## Proposal for a Selective Self-test

Pete McLean  
 Maxtor Corporation  
 2452 Clover Basin Drive Longmont, CO 80501  
 303 678-2149

25 February 2002

Modifications to ATA/ATAPI-6 revision 3a:

**Figure xx - Selective self-test test span example**

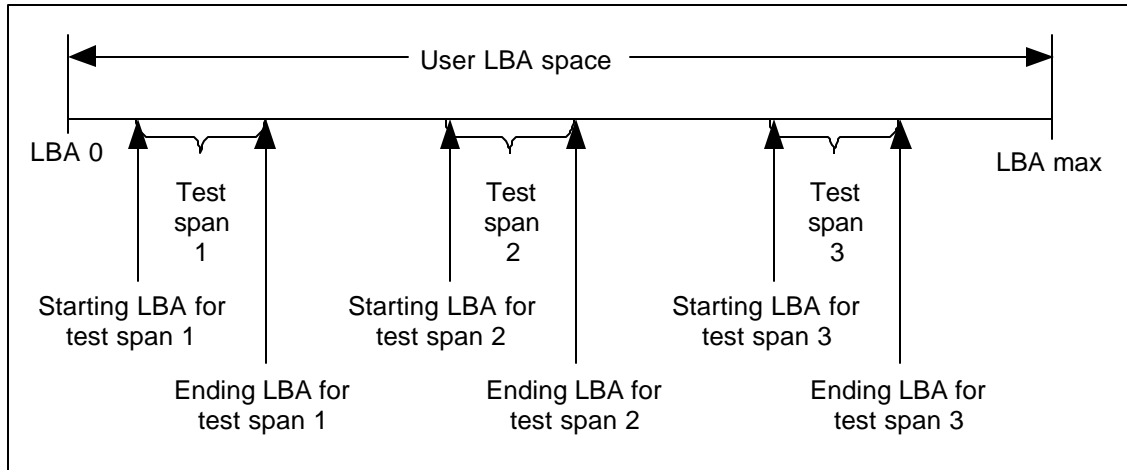
The user may choose to do read scan only on specific areas of the media. To do this, user shall set the test spans desired in the Selective self-test log and set the flags in the Feature flags field of the Selective self-test log to indicate do not perform off-line scan. In this case, the test spans defined

shall be read scanned in their entirety. The Selective self-test log is updated as the self-test proceeds indicating test progress. When all specified test spans have been completed, the test is terminated and the appropriate self-test execution status is reported in the SMART READ DATA response depending on the occurrence of errors. Figure xx shows an example of a Selective self-test definition with three test spans defined. In this example, the test terminates when all three test spans have been scanned.
